INSTRUCTION TO SERVICE

ITS: 58796	
SECTION:	304 Paint & Decals
WRITTEN BY:	Troy Stutsky
SUBJECT:	R&R the CNG vent location decals to meet the 2019 NFPA standard requirements

Figure 1: CNG vent decal locations and CNG fuel system plate on XN35 Buses

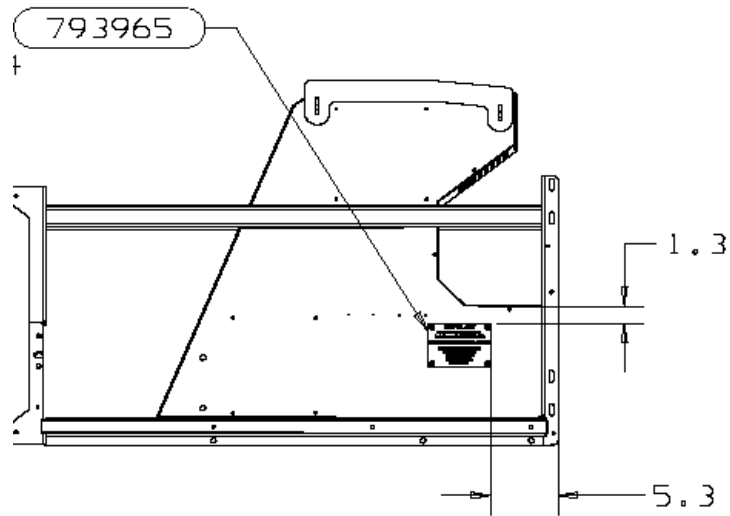
2. Remove and discard the existing CNG vent location decals on the roof of the bus in the locations shown in Figures 1, 2 & 3 depending on bus models listed in Figure descriptions.

4. Make sure the bonding areas are clean and dry and apply the new decals (NF PN 794114) in the same locations that the original decals were removed from as shown in Figures 1, 2 & 3 depending on bus models listed in Figure descriptions.

5. Remove and discard the existing CNG fuel system plate and rivets located in the engine compartment on the exterior of the engine belt guard as shown in Figures 1, 2 & 3 depending on bus models listed in Figure descriptions.

6. Install the new CNG fuel system plate (NF PN 793965) in the same location as the original one was. Fasten in place with four new rivets (NF PN 51R03007).
